PARTS DEPARTMENT BULLETIN

BULLETIN NUMBER: 2015-2

SUBJECT: Over Speed Board Part Numbers 46723 and 48801 are superseded to 56075.

Over Speed Board Kit PN 56075

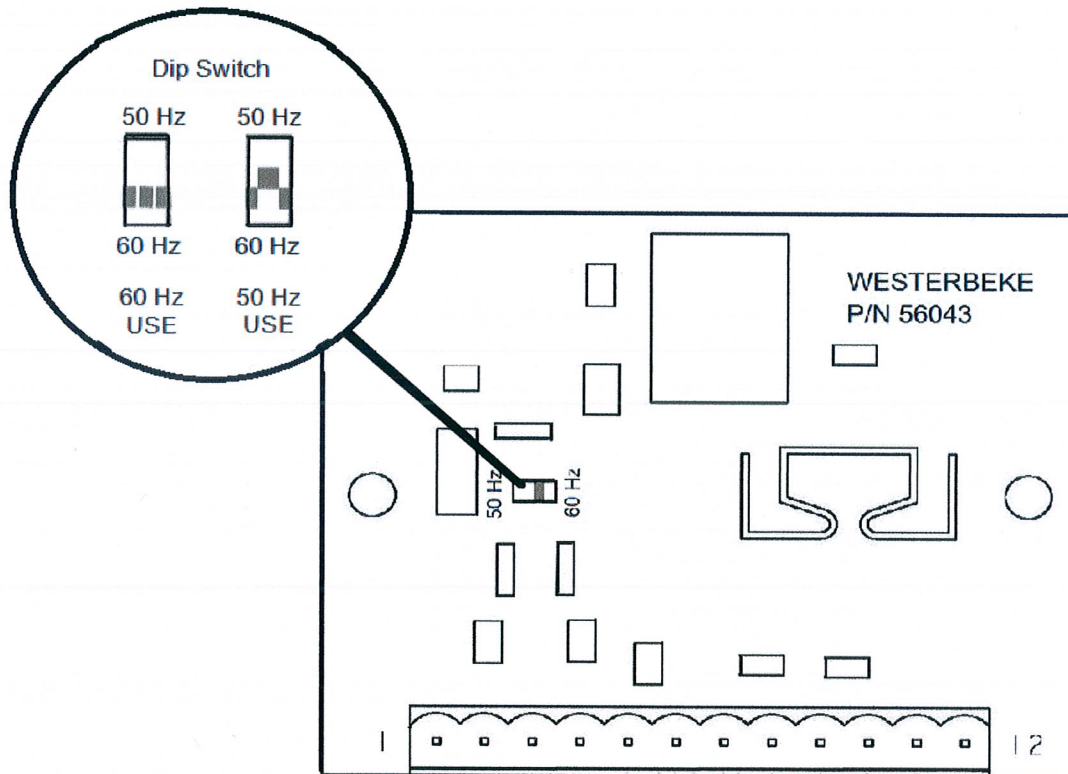
DETAIL: Improvements have been made to the over speed board used on the above listed models. This new board uses component surface mount technology increasing reliability. Trouble shooting this board is identical to the old style board. It plugs right into the existing wire harness with no other modifications.

The new board eliminates the need for two separate board part numbers for 50 or 60 Hz use. Board PN 56075 directly replaces boards 46723 and 48801. Easy field conversion of board is done by simply flipping a dip switch.
